## SITE PLAN REVIEW

LOT NO 63 REGISTERED PLAN 65M-4500

KLEINBURG GLEN VAUGHAN, ON

SITE PLAN

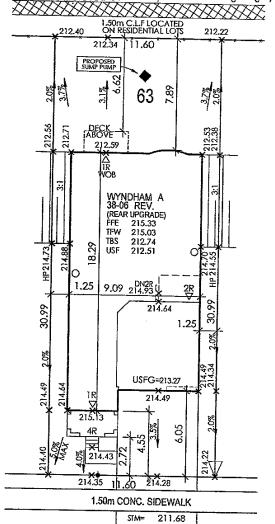
THE PROPOSED LOT GRADING AND DRAINAGE IS APPROVED AS BEING IN CONFORMITY WITH THE OVERALL APPROVED GRADING PLANS FOR THE SUBDIVISION.

COMMENTS AS NOTED DATE MAY 12:16
